## ***River District Design Commission***

**DECEMBER 13, 2018  
4:00 P.M.  
CITY COUNCIL CONFERENCE ROOM  
AGENDA**

*Request a Certificate of Appropriateness at 667 Craghead St. to construct an off-leash dog park.*

The Crossing- Off Leash Dog Play Park

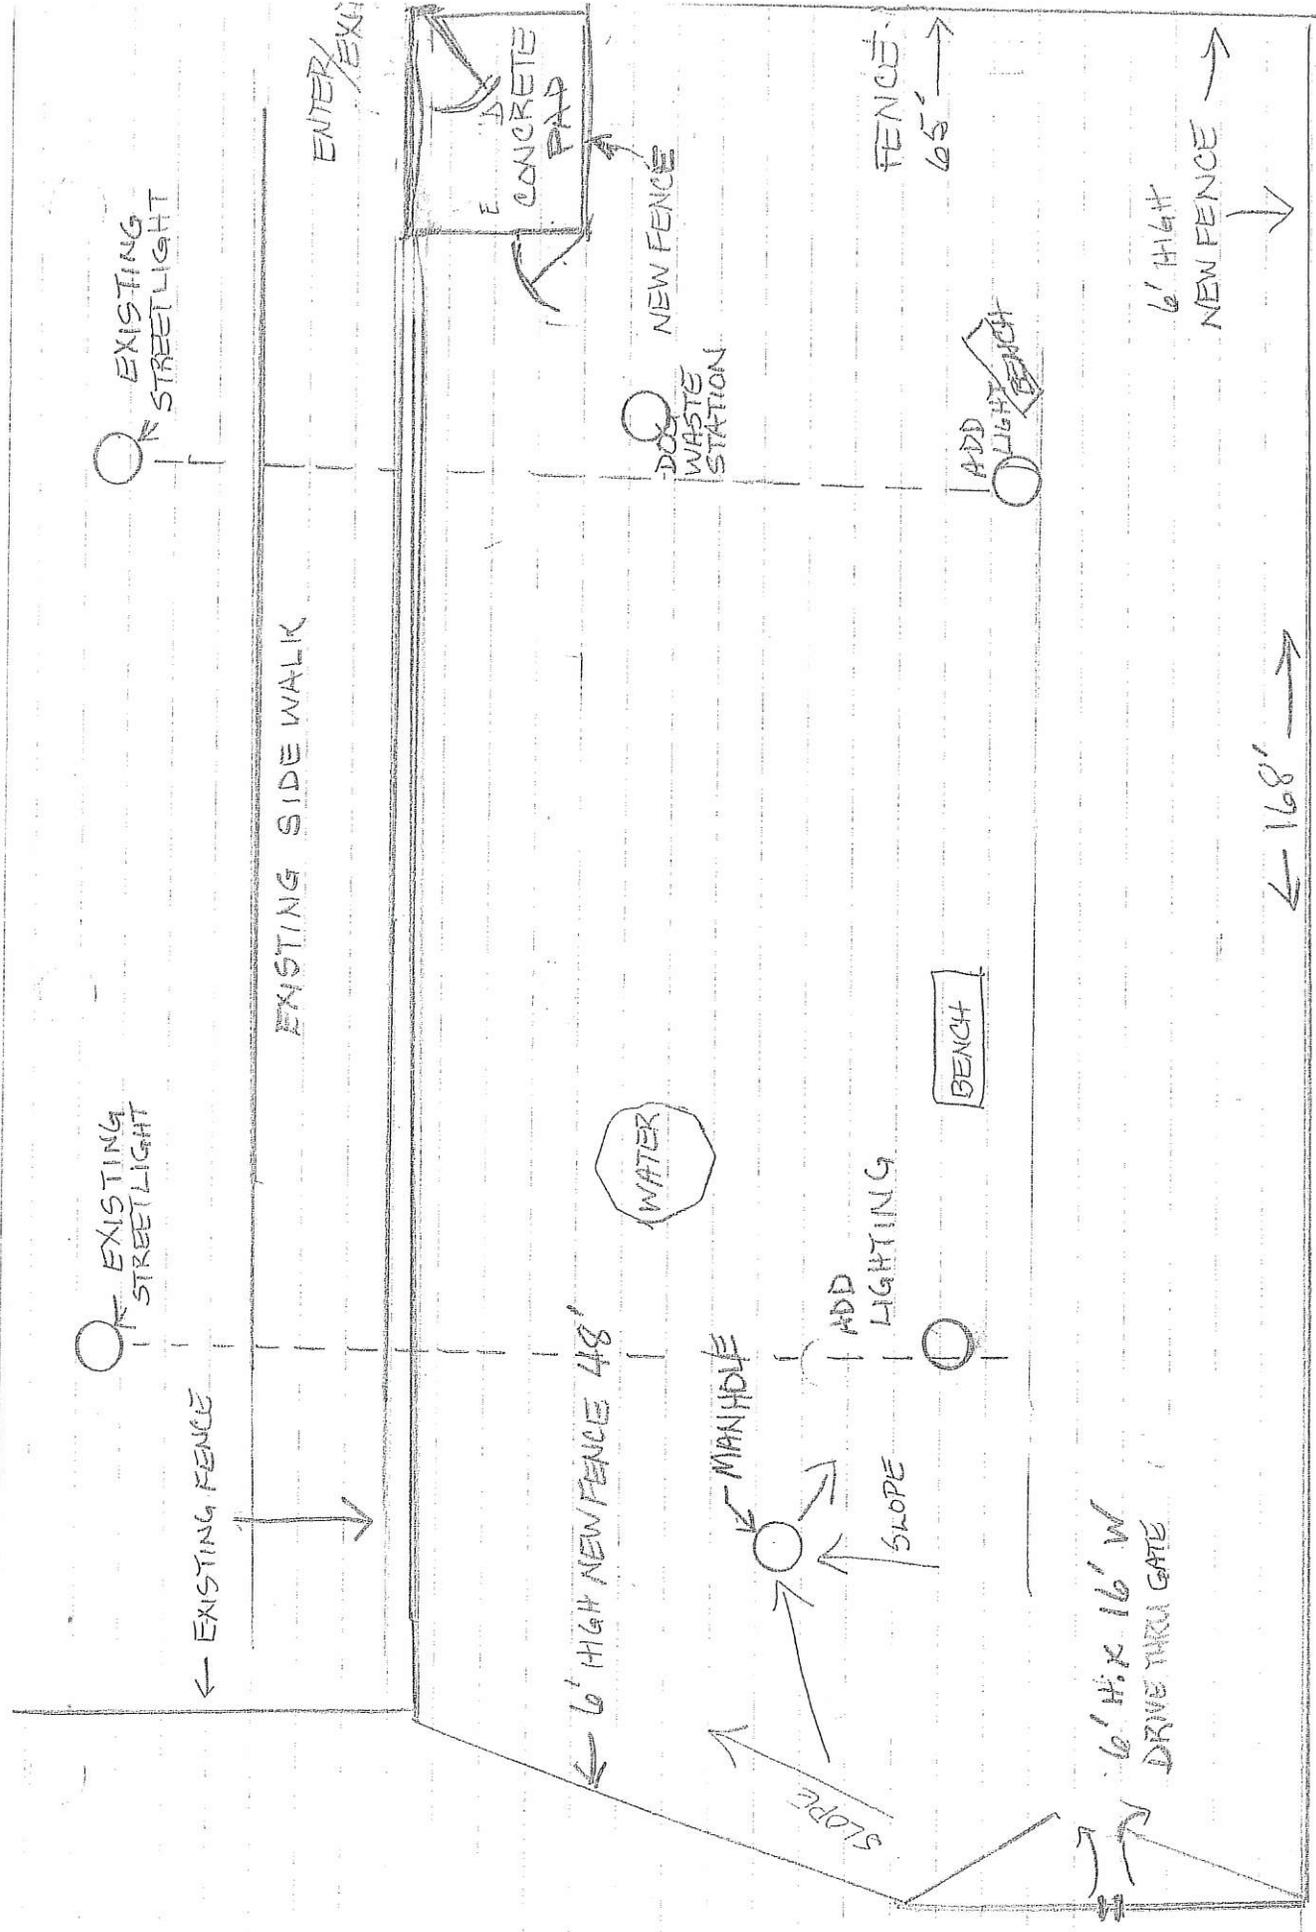
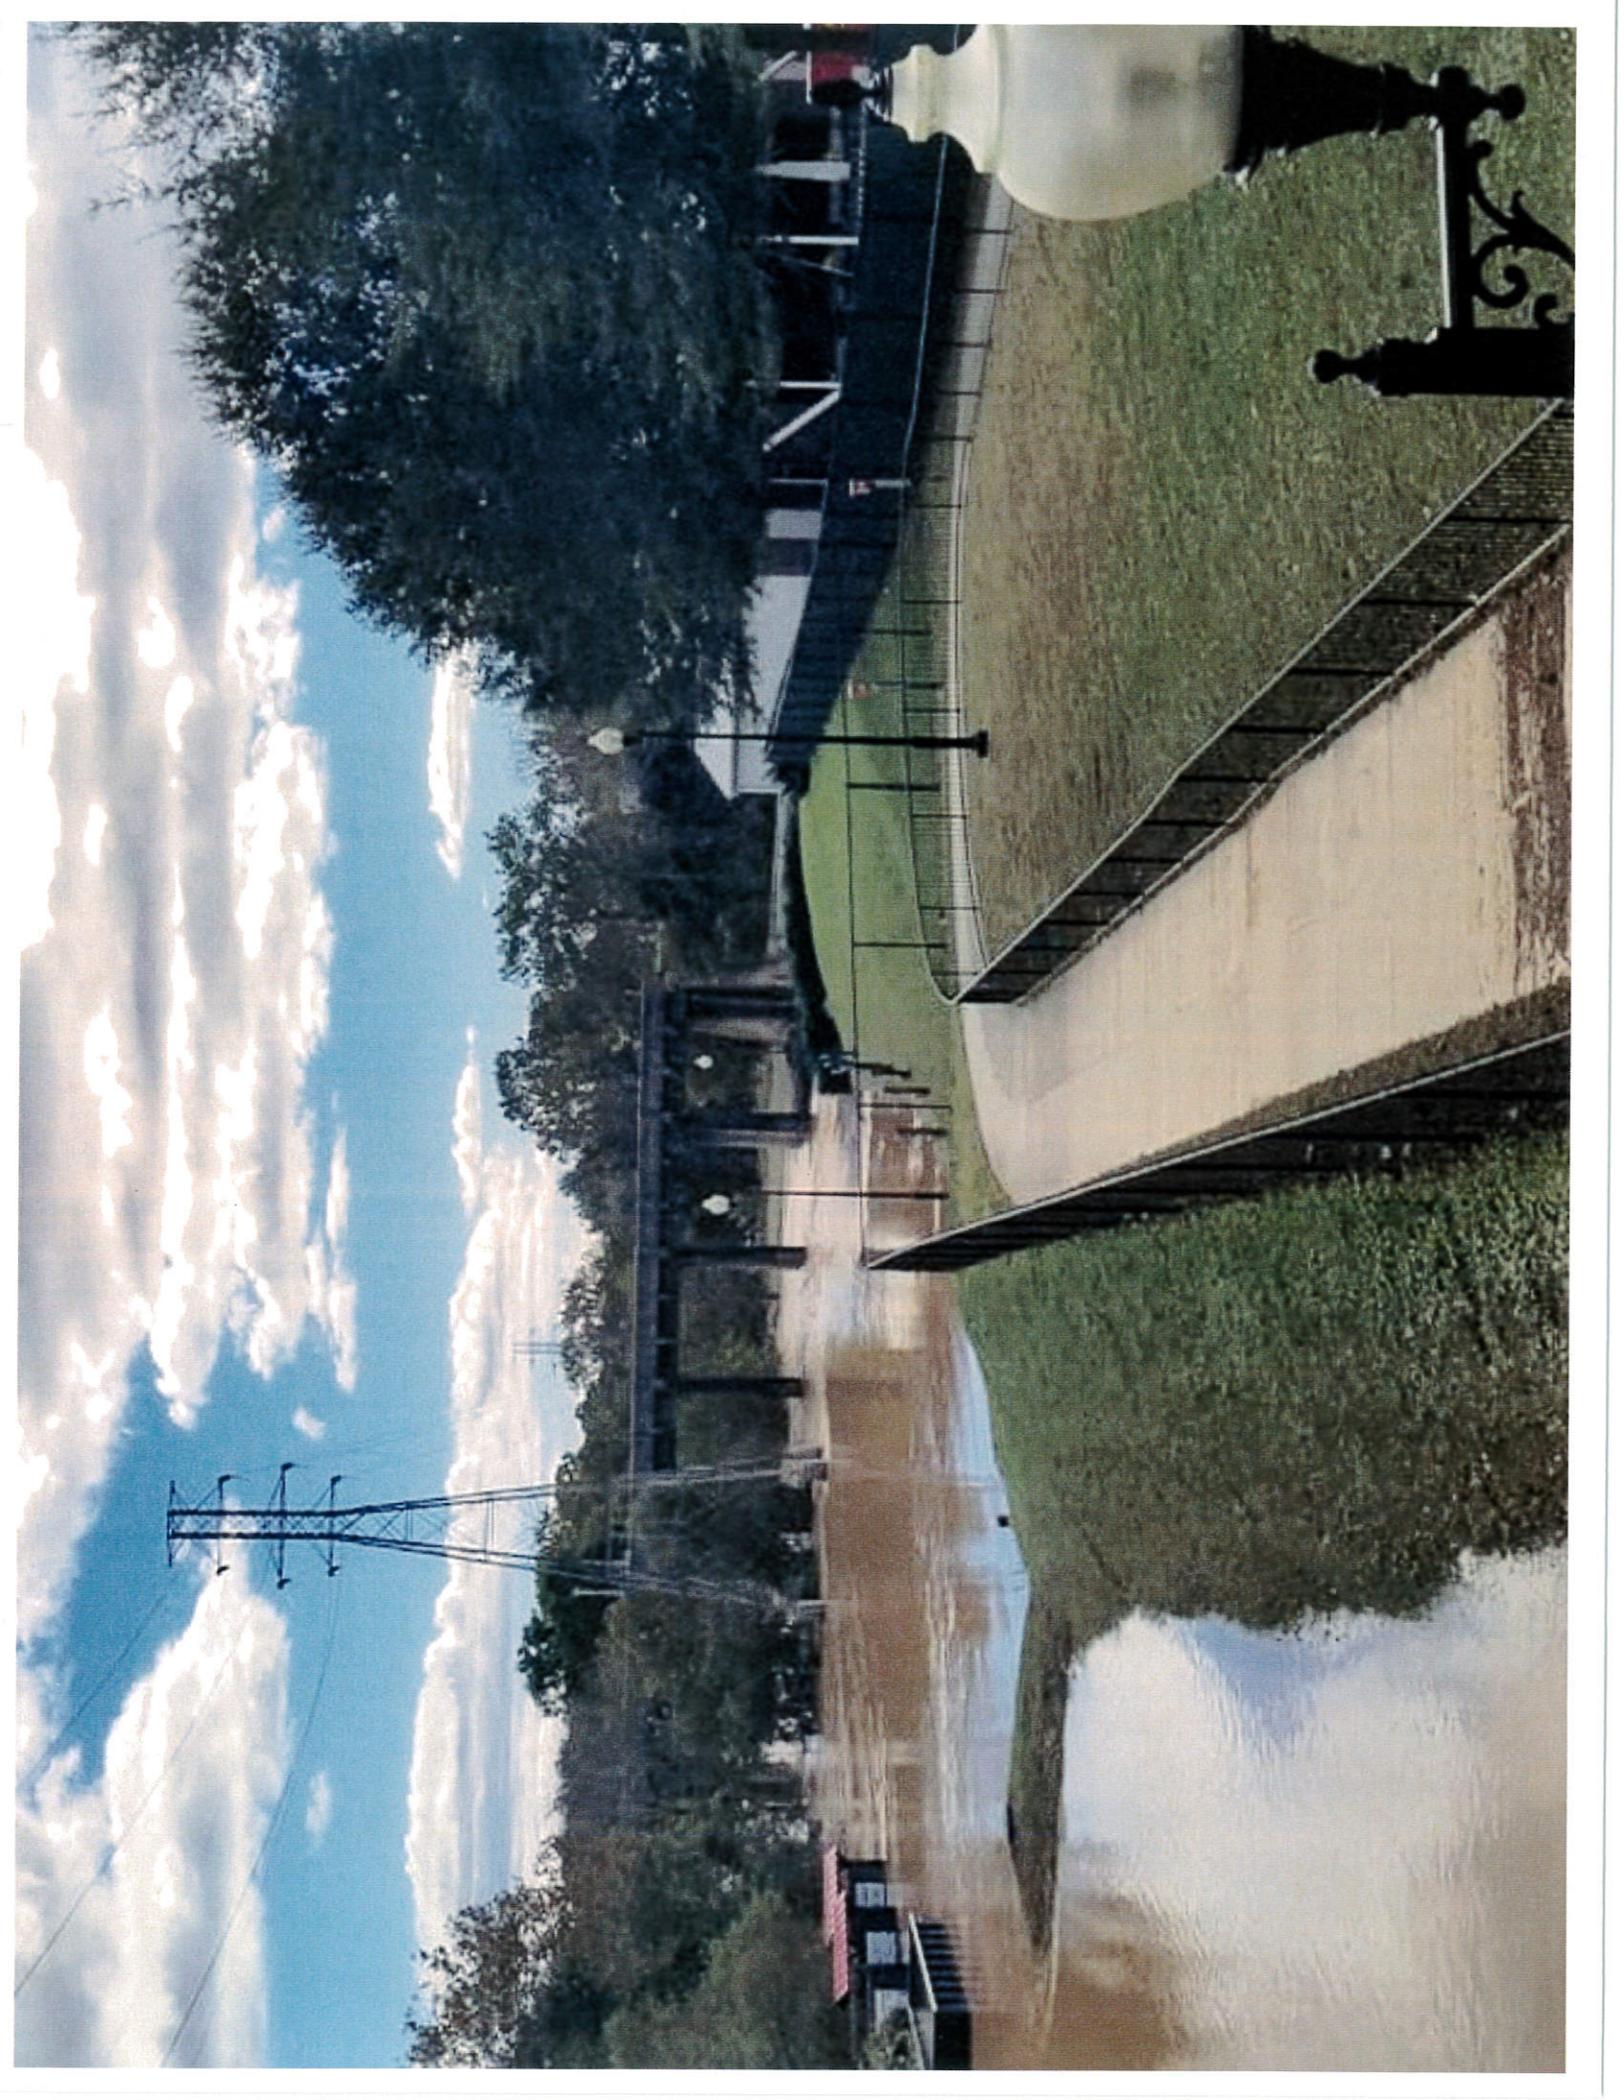
The proposed use of chain link fence is to address flooding concerns because most other recommended fencing would hold water within the park, thereby worsening flooding near the Dan River. Although there is recommended alternate fencing which would not hold water, such fencing would not be suited to containing dogs within the park.

The proposed the fencing will match existing fencing along the Riverwalk Trail and behind Carrington Pavilion, thereby providing consistent design elements through the public park area. The applicant has further addressed the fencing concern by proposing to cover the fence with removable fabric which would screen the fencing.

Staff recommends the River District Design Commission recognize that the request does not meet the guidelines. Staff further recommends that the Commission vote the discrepancy as minor, therefore permitting the Commission to vote for approval of the issuance of a Certificate of Appropriateness at 667 Craghead St to construct an off-leash dog park. The chain link fencing would be similar to that in the adjacent area along the Riverwalk trail and rear area of Carrington Pavilion.

Mr. Lackey stated are they going to use galvanized chain link?

Mr. Johnson stated I think chain link partially screened with fabric that can be taken off.

Mr. Ranson stated I thought that chain link fence was not allowed?

Mr. Gillie stated chain link fences are not approved material in the District. He is correct.

Mr. Lackey stated I think we should be consistent.

Mr. Lackey stated I'm all for a dog park being down there but I think consistency if we are going to enforce the rules against the private citizen then we need to enforce against the Government.

Mr. Gillie stated there is metal picket kind of type fencing that you can put in like wide iron. There is a couple options that are available.

**Mr. Lackey made a motion that we table this item. Mrs. Nicholas second the motion. The motion was approved to table by a 7-0 vote.**
